Access Compliance Report

Public Rights-of-Way

(Curb Ramps)

Intersection ID: 10024872	Main Street: DEWITT_LN	Cross Street: N/A	Location: NE
ADA ID: 0EA551DF309C	Ramp Type: Perp	Initial Pass/Fail: Fail	Overall Compliance: No
Severity Score: 10			
Codes/Mitigation Info/Possible Solution		Field Measurements/Component Compliance

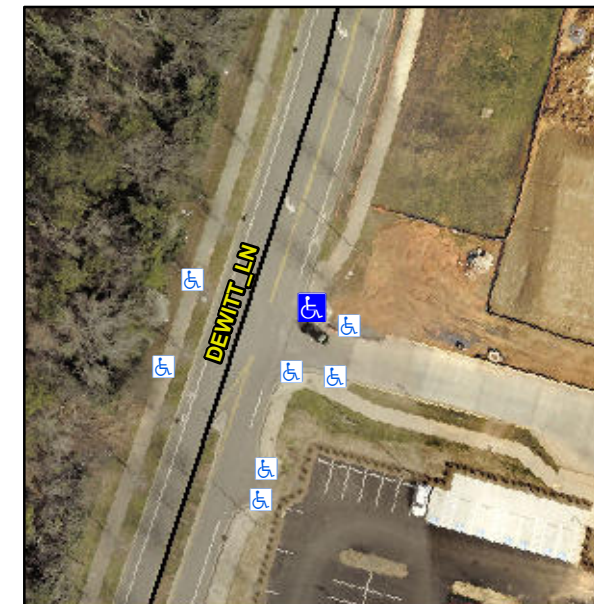
Not Found, R304.5.1

Compliance	Description	Data	Compliance	Description	Data
N/A	Ramp Length (in)	96.0	Yes	Ramp Slope (%)	6.3
No	Ramp Width (in)	43.0	Yes	Ramp XSlope (%)	2.1
N/A	Flare Type LT	N/A	N/A	Flare Type RT	N/A
N/A	Flare Slope LT (%)	N/A	N/A	Flare Slope RT (%)	N/A
N/A	Flare Traversable LT?	N/A	N/A	Flare Traversable RT?	N/A
N/A	Landing Length (in)	N/A	N/A	DWS Provided?	N/A
N/A	Landing Width (in)	N/A	N/A	DWS Contrast?	N/A
N/A	Landing Slope (%)	N/A	N/A	DWS Length (in)	N/A
N/A	Landing X Slope (%)	N/A	N/A	DWS Full Width?	N/A
N/A	Landing Curb? (Y/N)	N/A	N/A	DWS Offset (in)	N/A
N/A	Shared Landing?	N/A			
N/A	Gutter Ponding?	N/A	N/A	Gutter Slope (%)	N/A
N/A	Gutter Lip Ht (in)	N/A	N/A	Gutter X Slope (%)	N/A
N/A	Painted X Walk1?	No	N/A	Painted X Walk2?	N/A
	X Walk 1 Direction	To NW		X Walk 2 Direction	N/A
N/A	X Walk 1 Width (in)	N/A	N/A	X Walk 2 Width (in)	N/A
	X Walk 1 Slope (%)	0.6		X Walk 2 Slope (%)	N/A
	X Walk 1 X Slope (%)	2.5		X Walk 2 X Slope (%)	N/A

Remove & Replace Entire Ramp.
